State of Alaska
Department of Fish and Game
Sportfish Division

Nomination Form
Anadromous Waters Catalog

Anadromous Waters Catalog Number of Water Body 109-42-10010-2002-3001

Nomination # 24-724
Revision Year: 2025
Revision to: ☒ Atlas
☒ Catalog
Revision Code: C-9

Figure 1.—109-42-10010-2002-3001 route correction map.

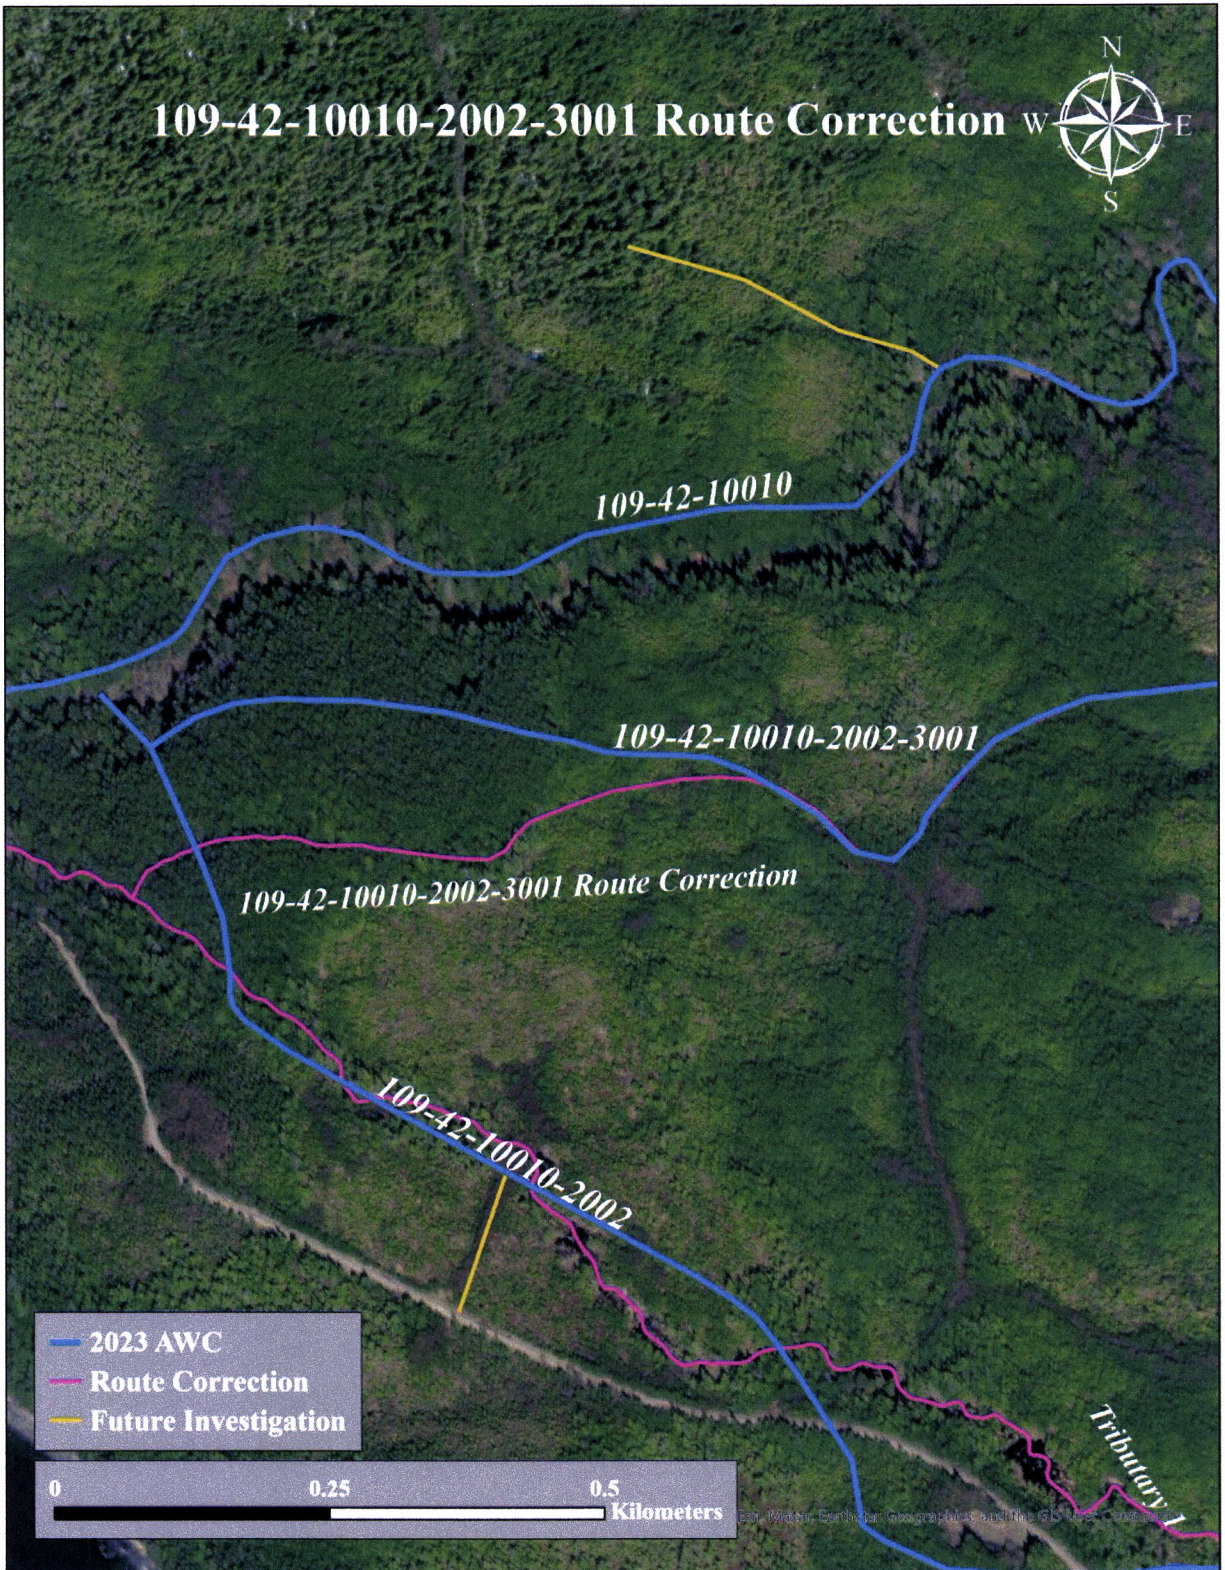
Findings: We surveyed the road crossing of this cataloged stream using a GPS and found that the stream path is incorrectly mapped. We recommend correcting the route of the stream to reflect the route identified by a LiDAR model of streams around Kake (Table 1; Figure 1).

Waypoint	Latitude	Longitude	Notes	Stream Width ft	Stream Substrate	Habitat Features	Gradient %	Sample Effort	Sample Results
227	57.017250	-134.015509	May want to correct route of tributary to follow LiDAR/imagery.

Recommendations: Correct Stream No. 109-42-10010-2002-3001 in the anadromous waters catalog to reflect the field verified stream path (Figure 1).
